To: Russell Butchers, Auckland Council
cc/- Drury Metropolitan Centre Consolidated Stages 1 and 2 Expert Panel

Re: Response to s67 further information recommended by Auckland Council Healthy Waters

This memorandum addresses Auckland Council’s second ‘s67 Information Gap Identification’ from Healthy Waters dated 5 June 2025 (“Auckland Council memorandum”) regarding the Drury Metropolitan Centre Consolidated Stages 1 and 2 listed project (“the Project”). The Auckland Council memorandum was sent to the Panel and copied to Kiwi Property No.2 Holdings Limited (“Kiwi Property”).

Figure 4: Area 1 - catchments

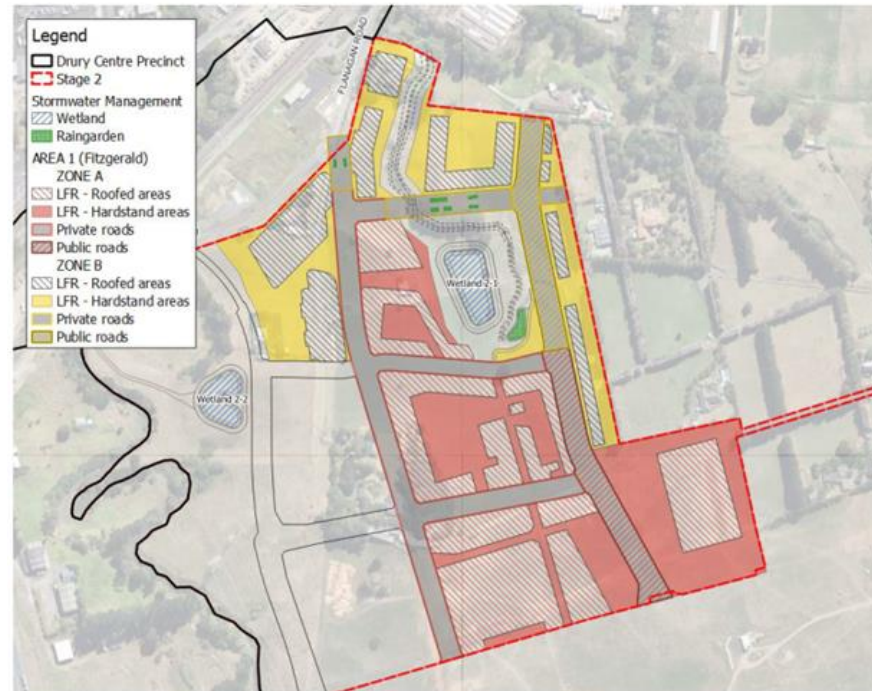
4.3	Updated calculations for Wetland 2-2 which are consistent with the calculations provided for Wetland 2-1 or justification of why this is not applicable.	<p>The design assumptions and allowances of the wetlands are outlined in Section 9 of 'Drury Centre Stage 2 Stormwater Assessment'. Both Wetland 2-1 and 2-2 have been sized in accordance with GD01 requirements and for the entire contributing catchment. The calculations account for volume reductions resulting from at-source hydrology mitigation and water quality treatment of roof runoff (see calculations in Attachment 1). As outlined in Section 9 of the report:</p> <ul style="list-style-type: none"> • Roofed areas of LFRs within Zone A, Area 1 – (discharging to Wetland 2-1) are proposed to provide retention at-source via tanks, which is considered BPO for water quality treatment. • Roofed areas of LFRs within Area 2 (discharging to Wetland 2-2) are proposed to provide retention and detention at-source via tanks, which is considered BPO for water quality treatment. <p>Following Healthy Waters feedback regarding the volume calculations for Wetland 2-2, the methodology has been revised to ensure alignment with the approach used for Wetland 2-1. The difference between the methodology had been identified with how the upstream at-source mitigation was accounted for:</p> <ul style="list-style-type: none"> • For Wetland 2-1, the mitigation was addressed by deducting volume from the total calculated volume. • For Wetland 2-2, the initial approach incorporated this mitigation by reducing contributing catchment area. <p>To ensure consistency across both wetland assessments, the calculations have been updated for Wetland 2-2 using the same methodology applied to Wetland 2-1 (i.e., applying a volume deduction approach). These calculations are included in Attachment 1. However, it is noted the outcome of this revised assessment confirms that the sizing of Wetland 2-2 does not differ from what's been provided in the report and meets the requirements of GD01.</p>

An overview of the treatment approach for the different zones and contributing areas is summarised in the table below with catchment areas of the two areas provided below.
